ITEM 1.8 (a)

Issue/ Objection:
Common Circulation and Spaces

**85 Harrington Street
The Rocks
GOLDEN AGE & HANNAS THE ROCKS**

**RESPONSE TO DoPE
ITEM 1.8 (a)**

APT 202,203,204 (and above) - AS SUBMITTED

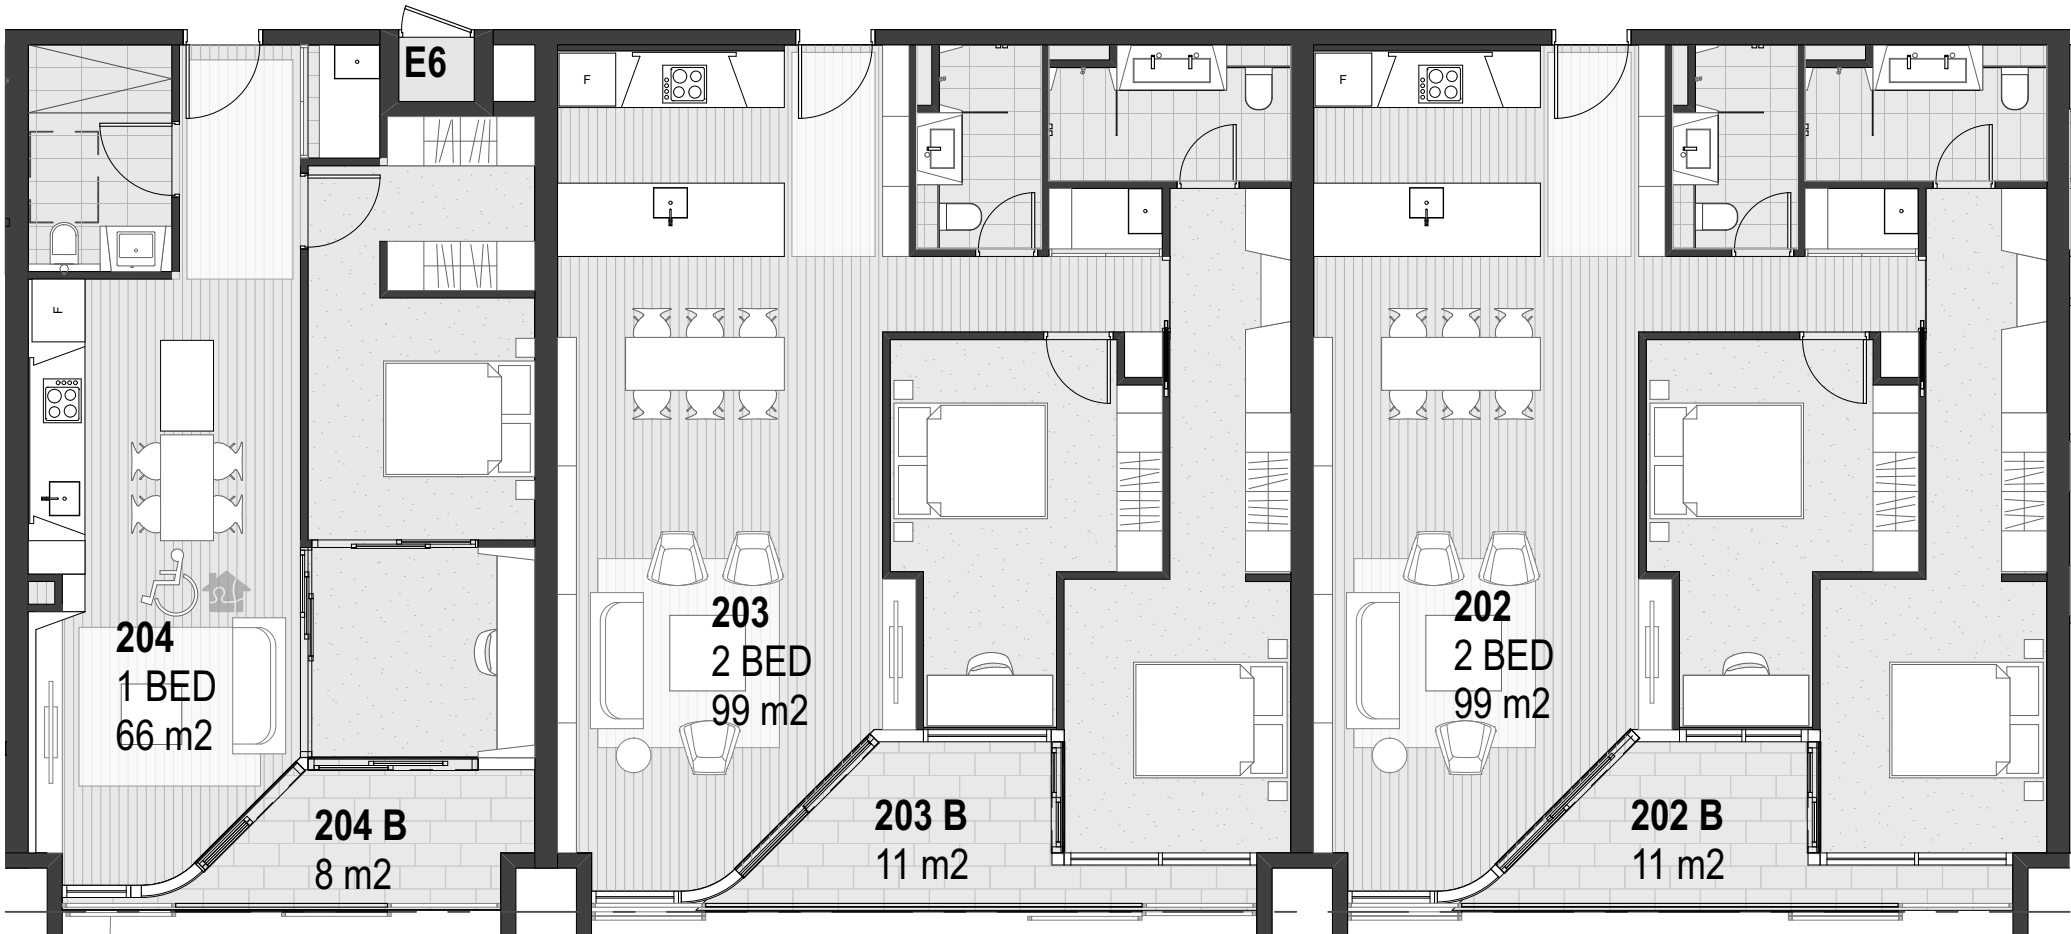
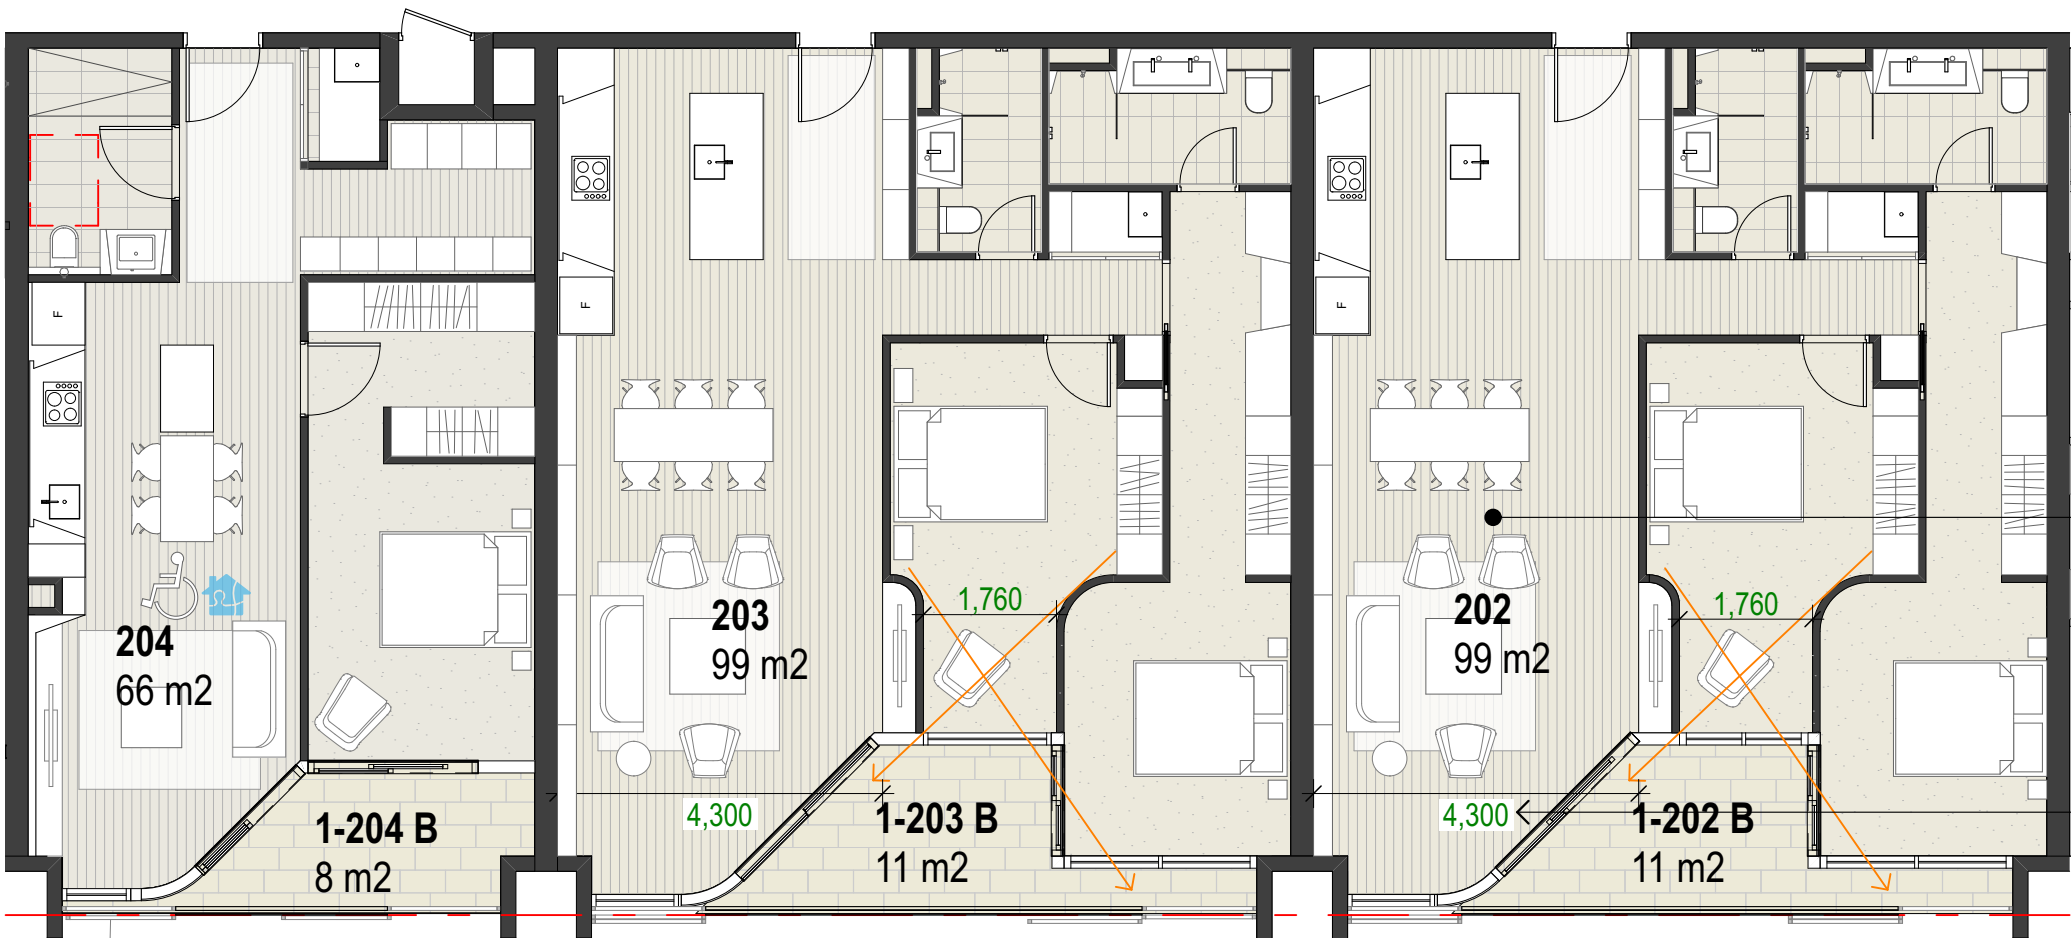
Description:
The Department's overall analysis indicates units 202, 203 and 204 (and identical units on the levels above) may not benefit from a satisfactory level of amenity due to a combination of variations to the Apartment Design Guide design criteria including solar access, cross ventilation, unit depth and/or lack of an external bedroom window.
The Department particularly notes the units which exceed 8 min depth are also not cross ventilated, further reducing effective air flow.
Please undertake further consideration of the design of these units to ensure a suitable level of amenity for future residents is achieved.

Response
Full consideration for the design of the apartments and the development as a whole have seen a change as response to the points raised by the department. See the above points as evidence of design changes and justification for all point raised.
Complies? Yes

- The internal area of apartments 202, 203 and 204 (and identical units above) are larger than that of the required minimum set out in the ADG (50 sqm for one bedroom and 75 sqm for two bedroom units. Therefore 202 and 203 (and identical units above are more representative of a three bedroom apartment than a two bedroom in terms of internal area.

- Furthermore, apartment 204 (and identical units above) take into consideration the needs for adaptability for accessible future residents.

- The width of the apartment is wider than ADG requirements providing 4.3m instead of the minimum 4m.

- Rotation of the kitchen will not achieve a greater amenity and will create a layout that is awkward and less usable than the current layout.

- The apartment has been amended to ensure that the bedroom receives natural daylight and air from a window in an external wall.

Exceeds ADG Objective 4D-3 - Living rooms or
combined living/dining rooms have a minimum width of:
▪ 3.6m for studio and 1 bedroom apartments
▪ 4m for 2 and 3 bedroom apartments
- The width of the apartment is wider than ADG
requirements, Providing 4.3m instead of the minimum 4m.
